CAL Document Change Notification

DCN No.
7650-DCN-0069-01

CHANGE TITLE: Updates To Calorimeter Module Assembly Drawing

DOC or DWG NUMBER	TITLE	AFFECTED REV.	NEW REV.
LAT-DS-00916	Cal Module Assembly	03	04

A

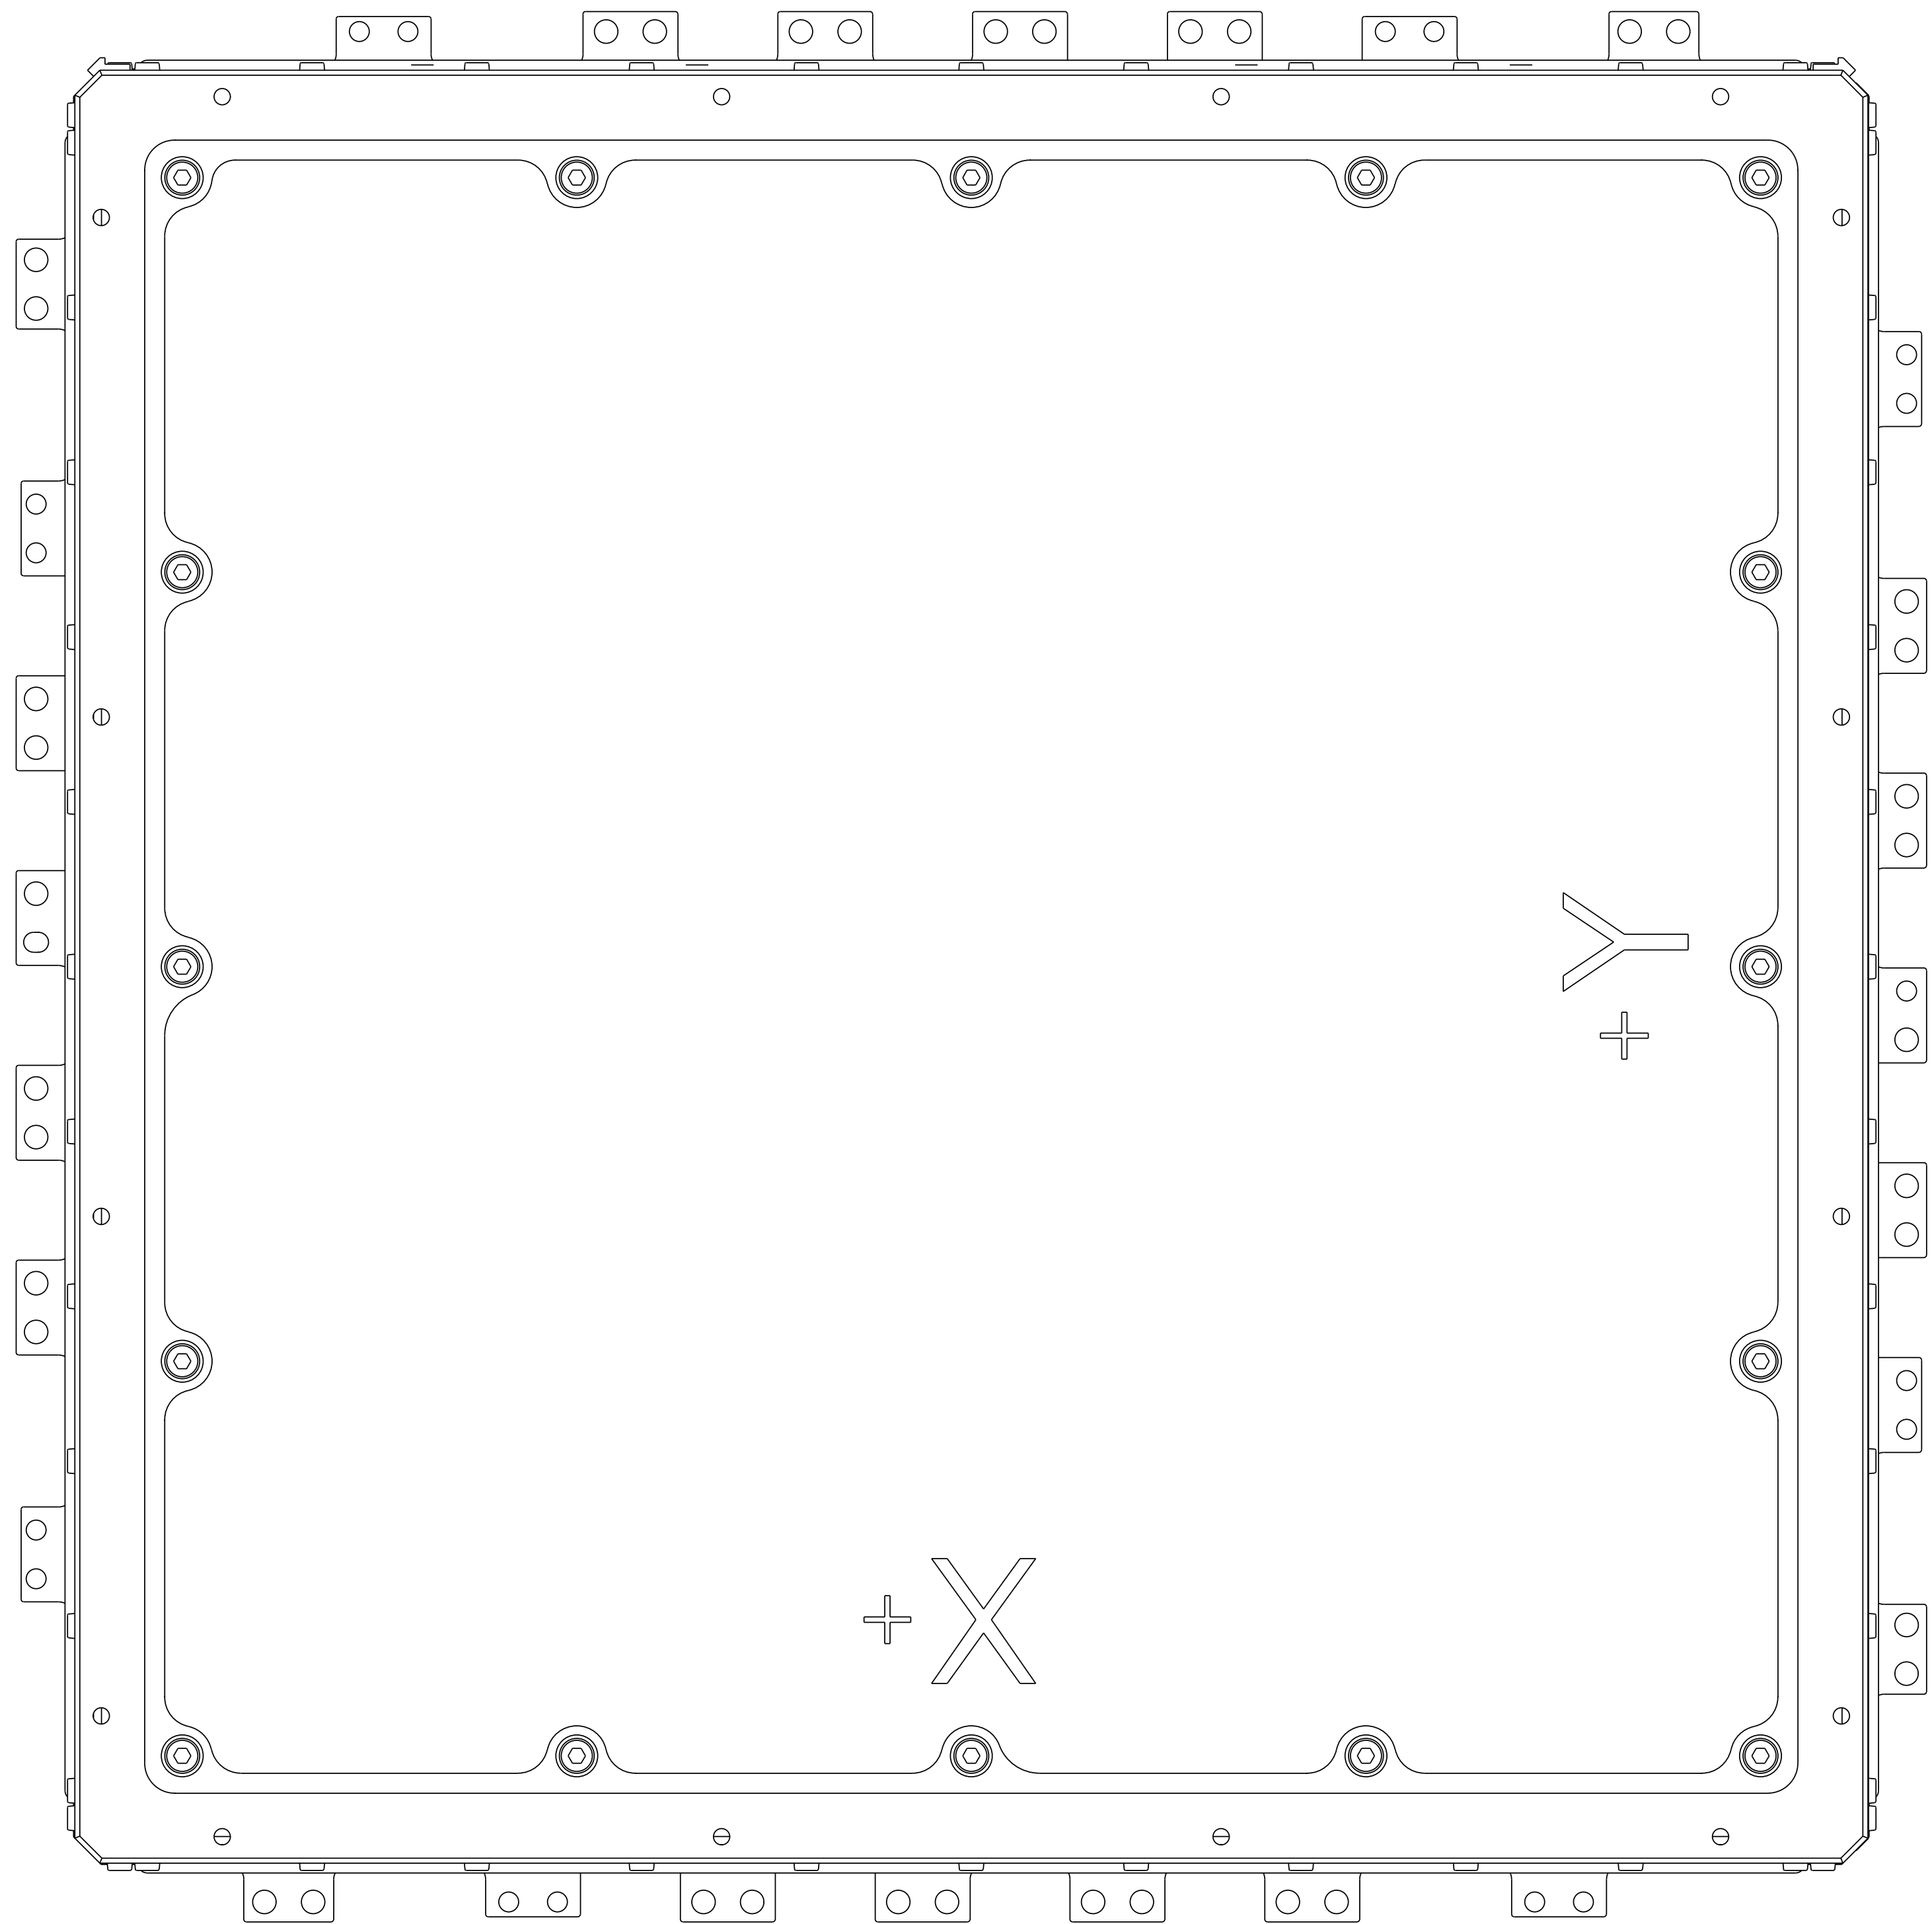
- 1) Update List of Materials with additional fasteners as shown:

REQD: 124
PART NO: NA0069-025006
DESCRIPTION: SCREW, SOCKET-HEAD, MJ2.5 x 6 mm L

REQD: 124
PART NO: 722-95-029-025-0.4B
DESCRIPTION: WASHER, FLAT, M2.5

- 2) Add Note Flag to AFEE Card Fasteners corresponding to additional parts listed in item 1)

Fasteners that secure the AFEE card to the PEM were not included in the version -03 of the drawing.
